PACKARD-CLIPPER DIVISION
OF
STUDEBAKER-PACKARD CORPORATION

VOL. 30, NO. 5

MAY, 1956

Converter Pump Shaft—Oil Pump Rotor Splines

Fig. 1

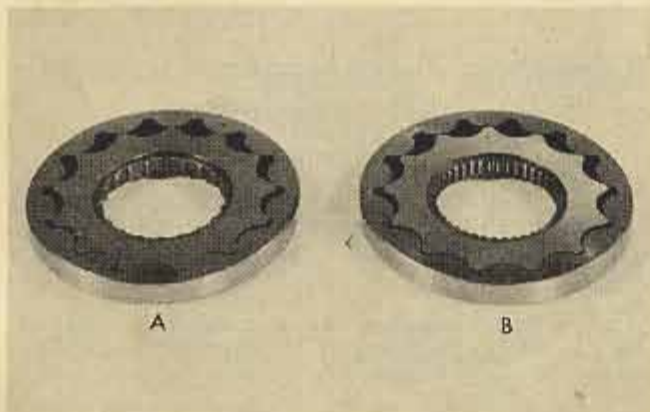
Several reports have been received of worn or stripped splines on the converter pump shaft where it engages with the front oil pump rotor and in some cases, the splines in the rotor were worn or stripped. This condition may occur in 54th Series Gear-Start transmissions, 55th and early 56th Series Ultramatic transmissions.

"A" figure 1, shows the front oil pump rotor having 20 internal splines that is used in 54th Series Gear-Start, 55th and early 56th Series Ultramatic transmissions.

56th Series Production transmissions starting with serial numbers A-9681, B-6012, C-1143, D-1862 have front oil pumps with the direct clutch passage in the rear and also have the rotors with 40 tooth splines on the internal driving section, "B" figure 1.

Whenever worn or stripped splines are found on one of the units, always replace both units to provide proper spline mesh.

Fig. 2

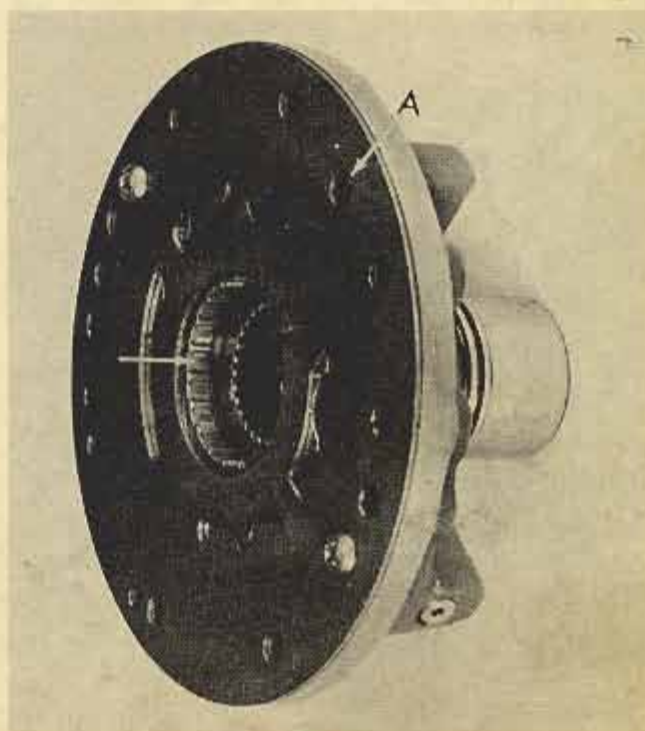
serial number 5-40469, oil pressure for the direct drive clutch came out of a passage on the front side of the pump. See "A" figure 2. The oil pressure is directed through a passage in the bell housing, then past the open splines in the rotor to the input shaft.

Fig. 3

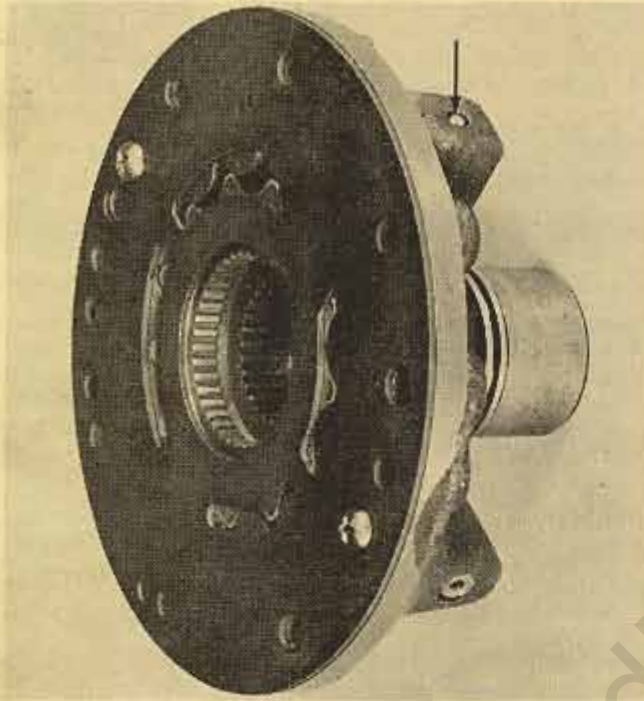
56th Series transmissions after the above serial number have front oil pumps with the direct clutch oil passage in the rear side of the pump. "See arrow figure 3." The outlet for this passage is between the two bushings inside of the pump hub, also note the oil passage hole is not in the front plate. However, these pumps have the 20 tooth splined rotors. (40 tooth rotor is shown in the illustration.)

The $\frac{1}{8}$ " holes are not required in the above listed Converter Shaft because the direct clutch oil passage is in the rear side of the pump body.

Fig. 4

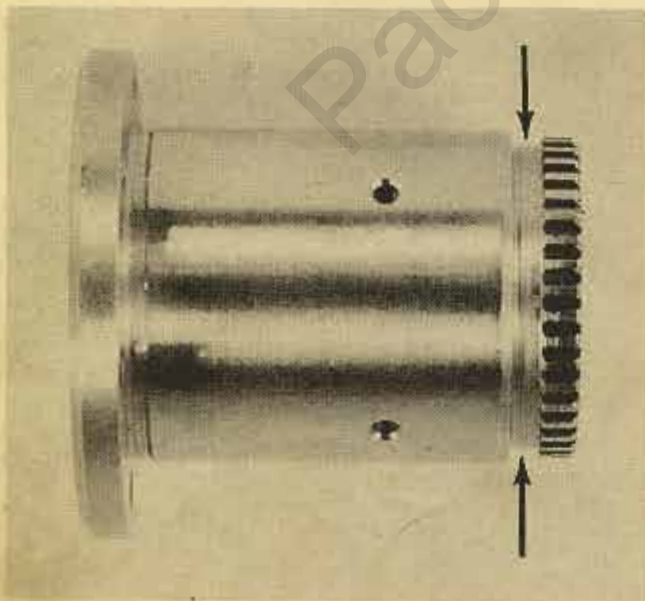
New rotors with 40 splines and front pump assemblies with 40 spline rotors have been released for service replacement and are listed for your ready reference.

The pump assembly listed above has the oil passage in the front side of the body and the rotor has 40 splines, therefore it will be necessary to drill six $\frac{1}{8}$ " holes evenly spaced through the annular groove just back of the splines in the converter shaft to provide an oil passage to the direct drive clutch. "See arrows figure 4." This also applies when replacing the rotor assembly. Be sure to remove burrs from edges of $\frac{1}{8}$ " holes and internal bushing after drilling.

Adjusting Accelerator Linkage

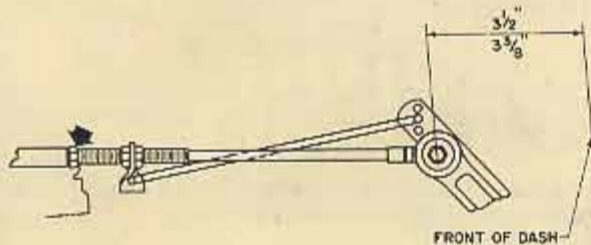
This linkage matches the transmission capacity with that of the engine and can materially alter the shift point if maladjusted.

1. With engine warmed up and carburetor off fast idle, set engine idle speed at 450 RPM with selector lever in "H" position.

2. Loosen the lock nut indicated by arrow in the illustration and adjust the length of the rod to obtain $3\frac{3}{8}$ " to $3\frac{1}{2}$ " measurement from the front side of the dash in the reinforcement channel to the center of the screw in the lever.

INSTRUCTIONS FOR INSTALLING BALL STUD AND SPRING CATCH IN THE FRONT SEAT STRUT ASSEMBLY TO ELIMINATE THE SEAT FROM FALLING FORWARD UPON SUDDEN APPLICATION OF BRAKES

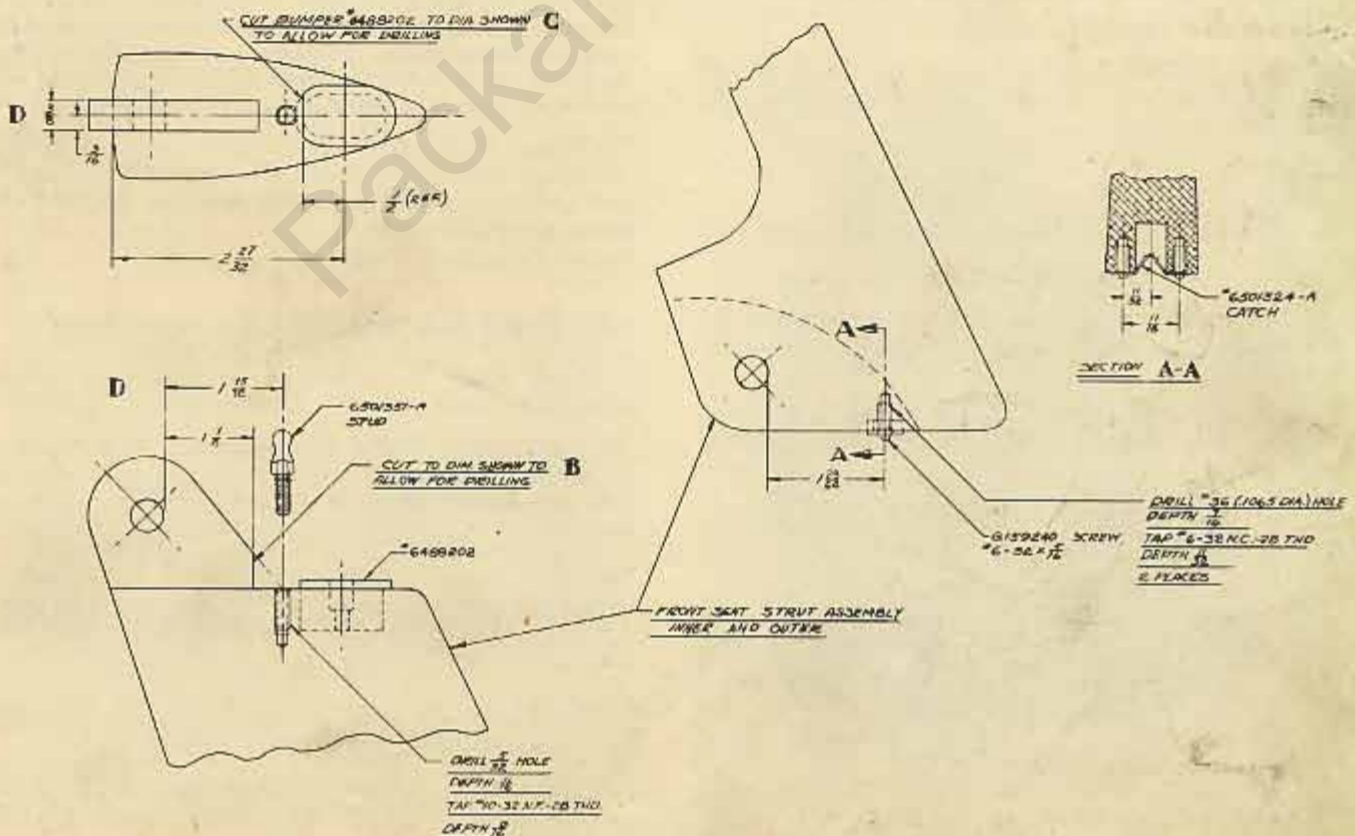
A few reports have been received of the right front seat back falling forward upon sudden application of the brakes.

Production is now installing a ball stud and spring catch on the seat struts to prevent this condition. The ball studs and spring catches are available for service, and can be installed as follows:

(a) Install the two hinge pins in the seat back struts.

(b) Using a 12" scale, line up one edge of the scale with the bottom of the strut with the end of the scale resting against the hinge pin.

(c) Measure $1\frac{29}{64}$ " distance and mark this location on the bottom of the strut.

(d) Set the spring catch in the strut as shown at the $1\frac{29}{64}$ " location.

Center punch, drill and tap two holes, using a No. 36 drill and 6-32 tap.

3. Measure $\frac{1}{2}$ " forward from the hole in the rubber bumper and cut off the edge of the bumper "C" to provide space for the stud.

(b) Mark the $1\frac{1}{8}$ " dimension and cut off portion "B" of the strut to provide space for drilling and installation of the stud.

(c) Using the 12" scale, mark the $1\frac{15}{32}$ " location as indicated by "D."

(d) Center punch, drill and tap one hole in the exact center of the strut using $\frac{5}{32}$ " drill and 10-32 tap. Perform the same operation on the other seat frame strut.

Inside Door Handle Retainer

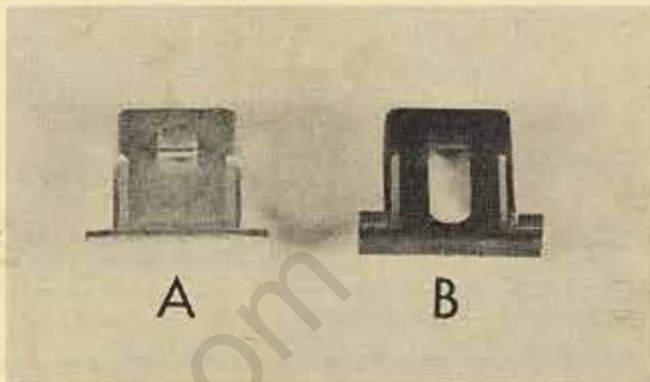
The inside window regulator and door lock remote control handle retainers have been revised to prevent the handles from falling off.

The old retainer is indicated by "A" and the new is indicated by "B" in the illustration.

The new retainer can be ordered under Part Number 6485347.
